SERVICE BULLETIN

Classification: BR06-006c	Reference: NTB06-037c	Date: October 27, 2006
------------------------------	--------------------------	---------------------------

2005 FRONTIER AND XTERRA; SQUEAKING NOISE FROM BRAKES

**This bulletin amends NTB06-037b. Parts Information has changed.
Please discard all previous copies of this bulletin.**

Figure 1

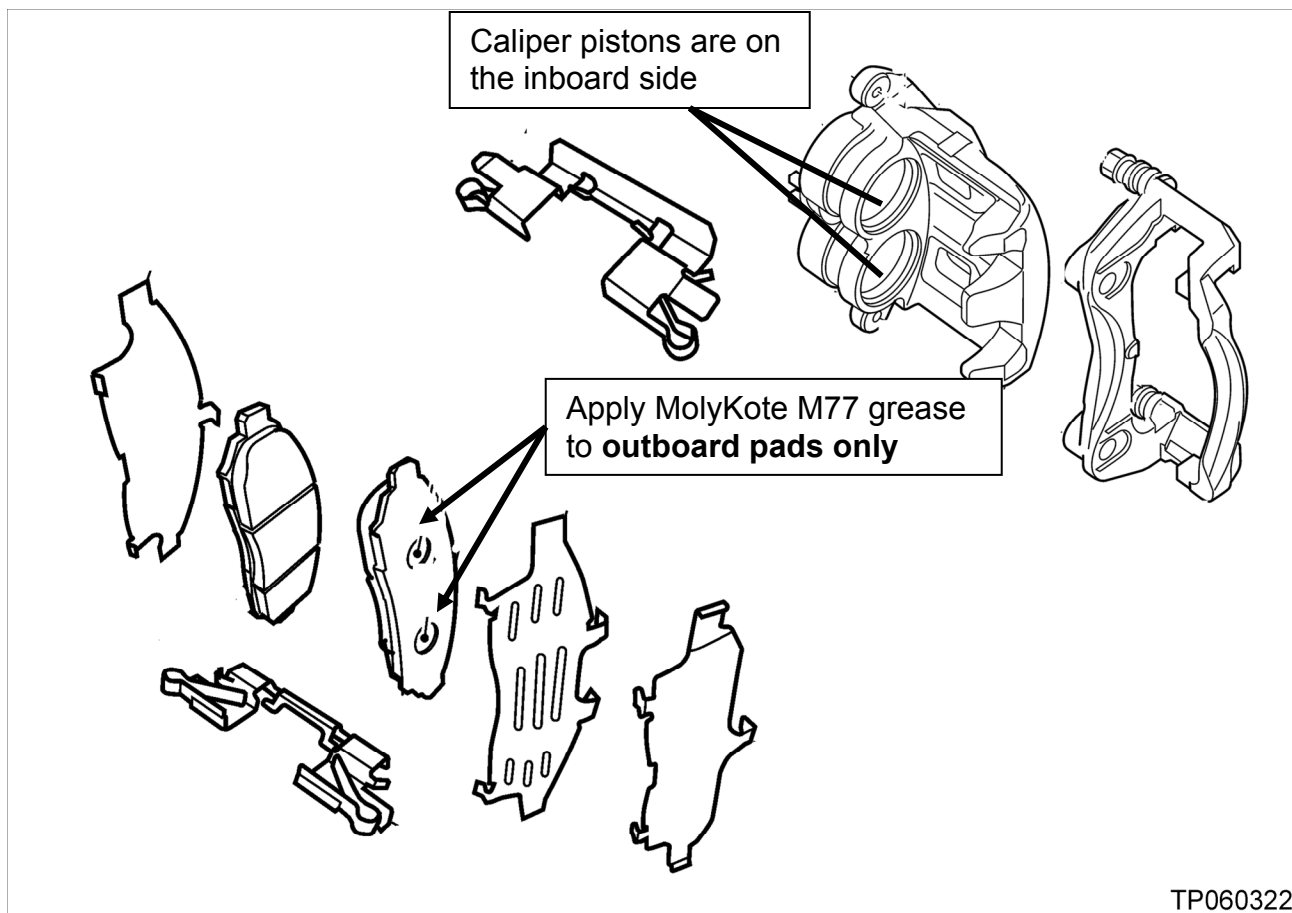
- Make sure the shims are installed as shown in Figure 1.

- Apply Molykote® M77 grease to the back side of the **outboard** brake pads **ONLY** (see Figure 1).

Figure 2

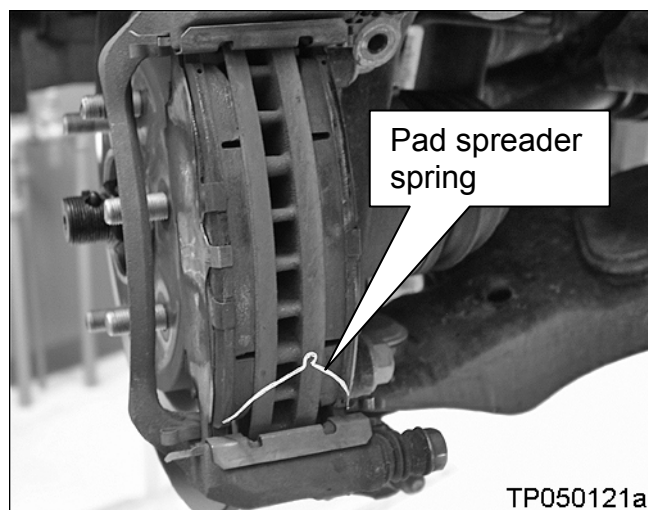
- Make sure to install the brake pad spreader spring as shown in Figure 2.

Figure 3

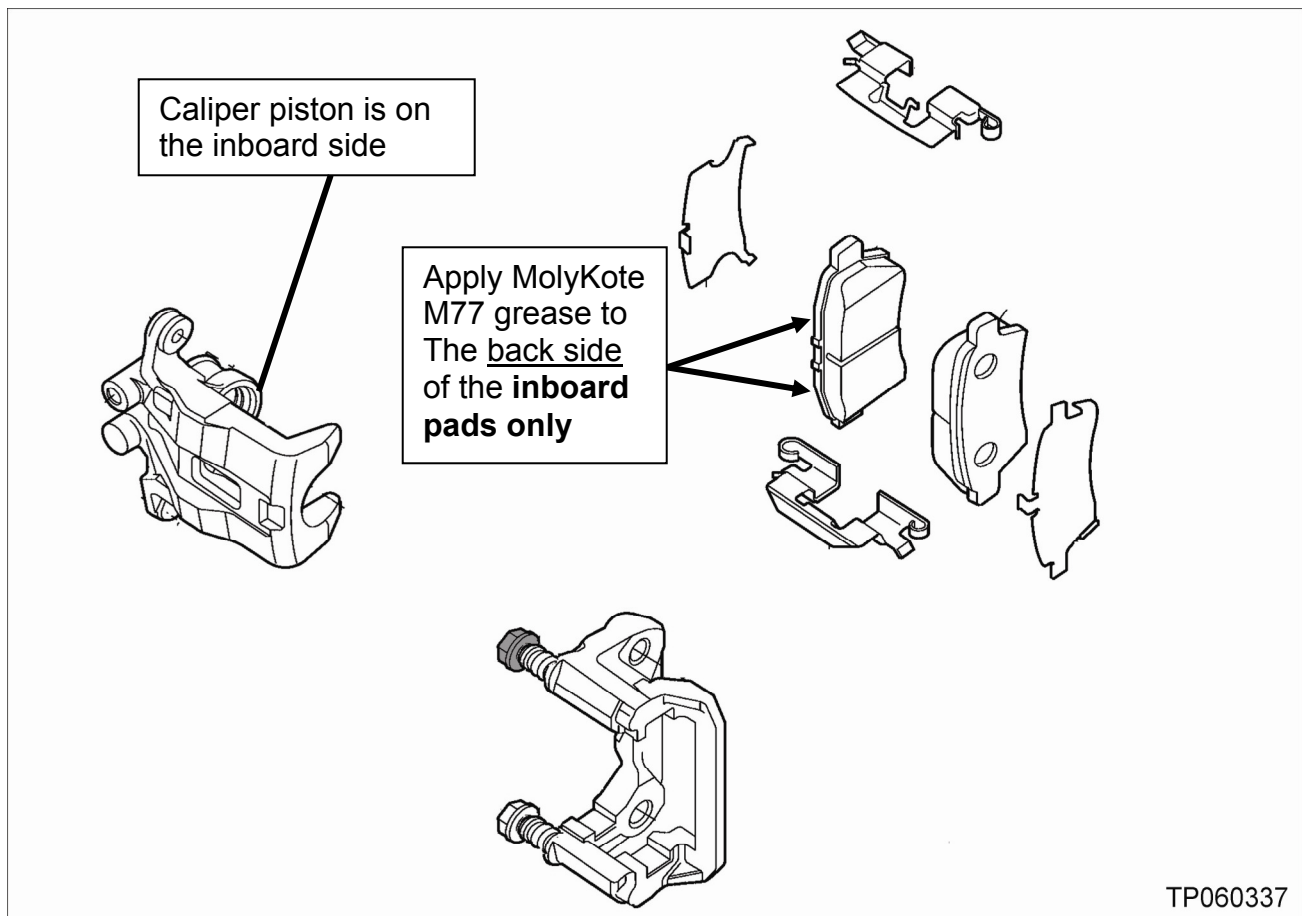
IMPORTANT: Apply Molykote® M77 grease to the back side of the inboard brake pads **ONLY** (see Figure 3).
